Kenai Peninsula Borough

Plat Committee

September 13, 2021
5:30 p.m.
UNAPPROVED MINUTES

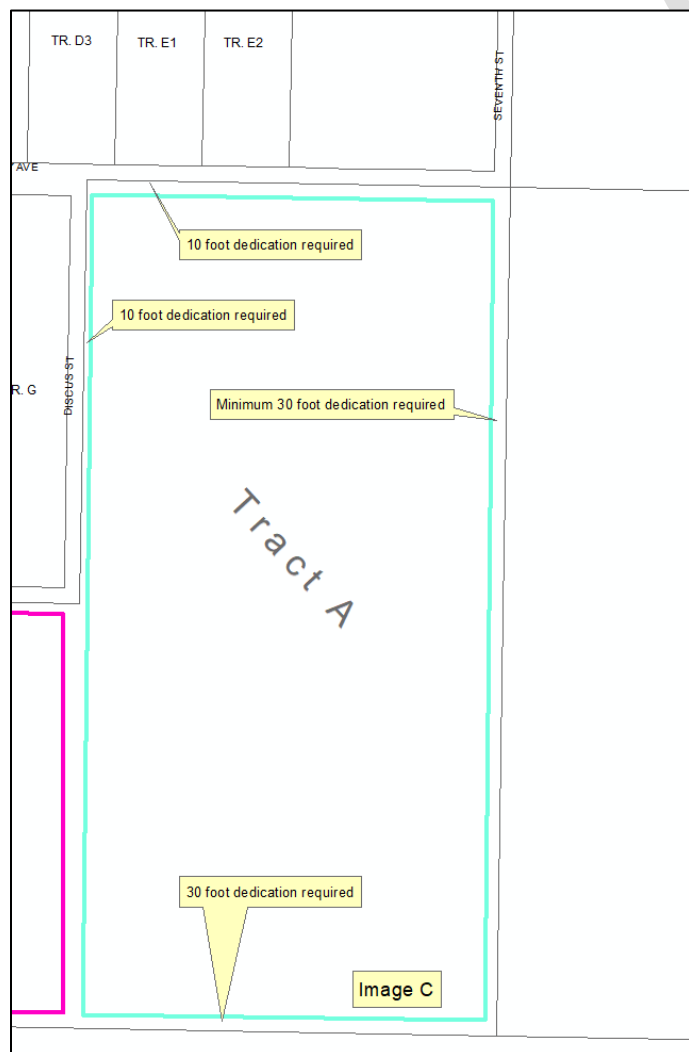
Tiller Avenue and Farmstead Street are currently 50 foot wide dedications. Sheet 2 indicates that 10 foot dedications are proposed and a 30 foot dedication along the south that coincides with a 50 foot section line easement (Image B).

A 60 foot wide dedication is proposed to provide a continuation of Discus Street. The design proposed shows a 10 foot offset from the northern dedication. This appears to be occurring due to unit locations. As discussed previously, this plat cannot change any unit design. **Staff recommends** the right of way dedication for Discus Street be 60 feet wide and align with the current dedication of Discus Street. (Image B).
